Submissions Report Modification 3

SILVERTON WIND FARM

OCTOBER 2016

Silverton Wind Farm

Figure 5-1 Approved and modified wind turbine envelopes, showing maximum rotor diameters (to scale).

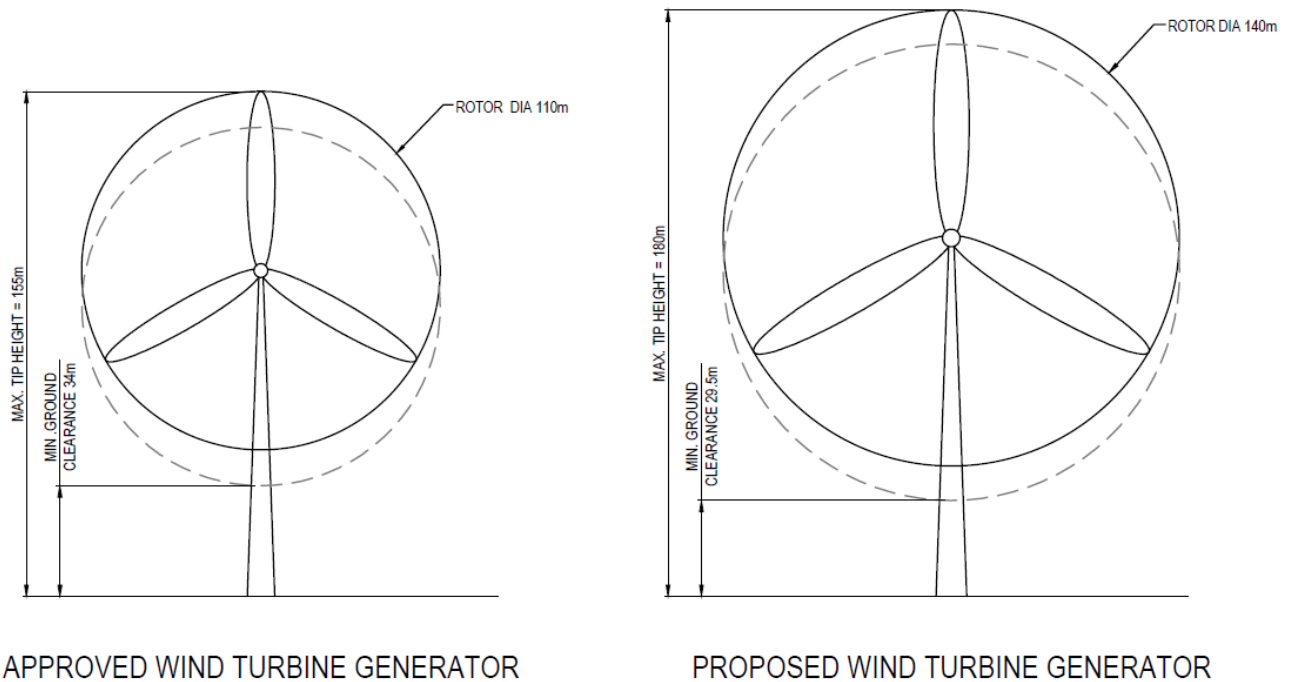
Approval is sought as part of this modification to allow up to approximately 140 meters rotor diameter. Refer to Table 5.1 and Figure 5.1 for the maximum rotor diameter and minimum ground clearance considered in the approved versus Modification 3 layouts.
